**BEFORE THE PUBLIC UTILITIES COMMISSION
OF THE STATE OF CALIFORNIA**

**COMMENTS OF THE GREEN POWER INSTITUTE
ON THE 2022 WMP UPDATES OF THE SMJUS**

June 20, 2022

The GPI performed a review of the SMJUs' 2022 WMP Updates with a general focus on risk modeling and the reduction of green waste from vegetation management mitigations. Our comments focus on PacifiCorp and Liberty's 2022 WMPs, and secondarily address issues in the Bear Valley Electric Service (BVES) WMP. This is not, however, a reflection on the importance of holding BVES and their Wildfire Mitigation Plan to equally high standards. Based on our review we have substantial concerns regarding PacifiCorp's 2020–2021 performance and 2022 work plan and associated costs. We recommend issuing PacifiCorp a revision notice that addresses the disconnect between past versus proposed performance and costs. We provide further comments on the following topics:

Figure 1. PacifiCorp 2020-2022 Planned WMP cost

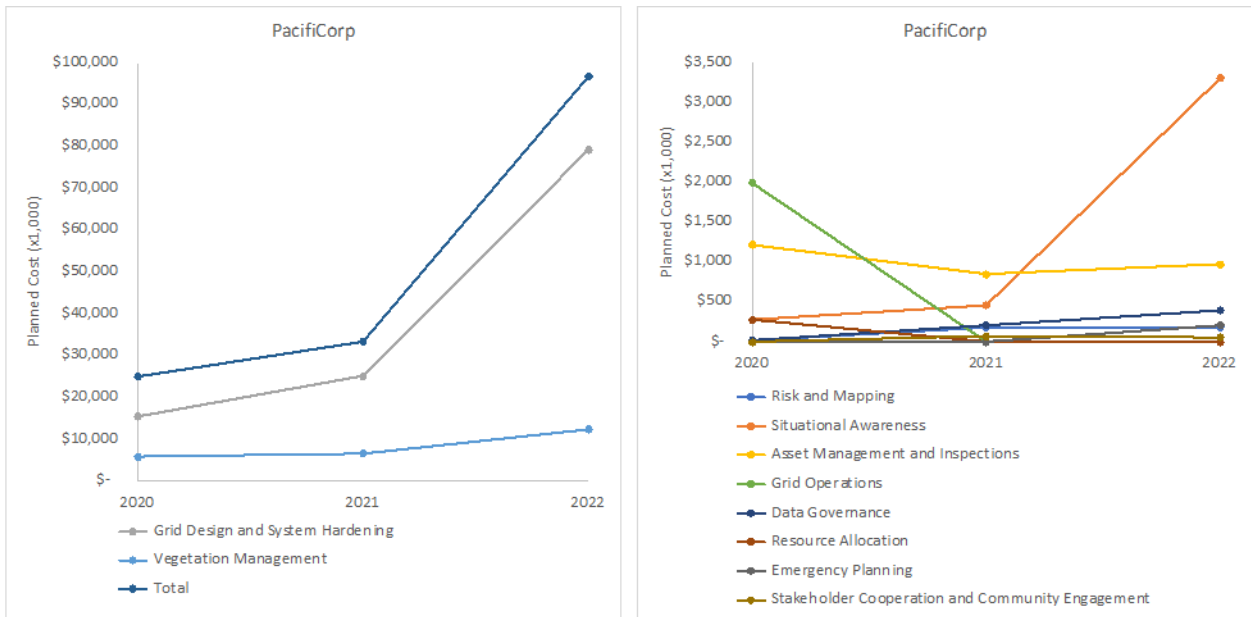
reinforcement program targets were increased from 128 poles in 2021 to 2020 poles in 2022. They are also launching a dedicated expulsion fuse replacement program with a target of 2269 fuse replacements in 2022. These Grid Design and System Hardening program expansions are behind a 3.2-fold increase in program costs from 2021 to 2022, and are the driving force behind an overall 2.9-fold increase in total annual WMP cost (2021 to 2022, Figure 1).

Despite PacifiCorp's 2021 expenses being on target for planned Vegetation Management costs (table 1), they are electing a 1.9-fold increase in the planned cost of 2022 Vegetation

Management activities (Figure 1). This increase in cost is not supported by their 2022 Vegetation Management program targets (PacifiCorp 2022 WMP, p. 119), which are on par with planned targets and/or work completed in 2021. The largest planned increase in 2022 work relative to 2021 planned and/or completed work is in VM activities around transmission lines. However, the majority of wildfire risk exposure, including for vegetation risk drivers is located on the distribution system. PacifiCorp should justify this cost increase relative to their VM program targets.

Figure 4. Reproduction of Figure 4.20 from PacifiCorp’s 2022 WMP Update.

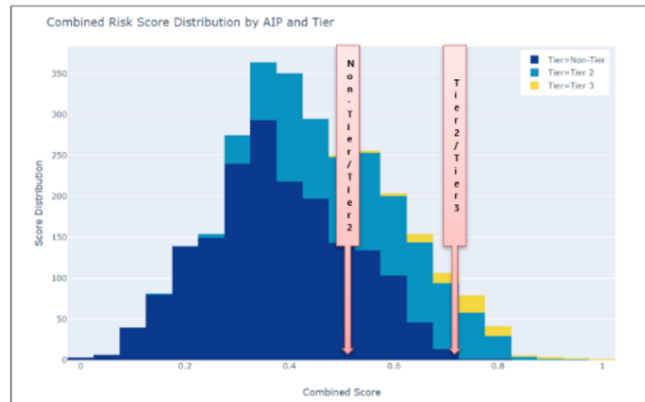
They have, however, developed a combined risk score for Zones of Protection (ZOP), retained Reax for fire spread modeling in the past, and now contract with Technosylva which provides fire spread modeling (FireSim) as well as weather forecasting (FireCast) and risk assessment platforms (WRRM). PacifiCorp also presents their combined LRAM risk scores for ZOPs in a histogram figure where they establish risk boundaries roughly based on the coincidence of HFTD Tier 2 and Tier 3 regions (PacifiCorp 2022 WMP Update, p. 93). Notably, these selected risk boundaries include carry over of Tier 2 and Tier 3 regions into all three of the risk "zones" subset by PacifiCorp's selected "risk boundaries" (Figure 4).

PacifiCorp clearly has the data necessary to produce more granular wildfire risk maps of their territory based on wildfire spread (i.e. consequence), weather, and some gauge of probability of ignition (PoI). These data are products of their previous contract with Reax, current contract with Technosylva, and other in-house risk models (e.g. LRAM). In their Maturity survey, PacifiCorp also reports relatively high self-rankings for A. Capability 5: Risk mapping and simulation algorithms, including maturity levels that include "independent evaluations and historical data (A.V.d [iii of iii])" and "current and historic ignition and propagation data; near-miss data (A.V.e [iii of iv])." Given clear risk map reporting requirements and the high Maturity Survey self-scores it is unacceptable for PacifiCorp to not provide their detailed, granular risk maps in the WMP. GPI recommends requiring that PacifiCorp provide their more granular wildfire consequence and PoI risk maps for the 2022 WMP filing prior to plan approval. They should also be required to propose HFTD expansions if warranted by these data in their 2023 WMP Update.
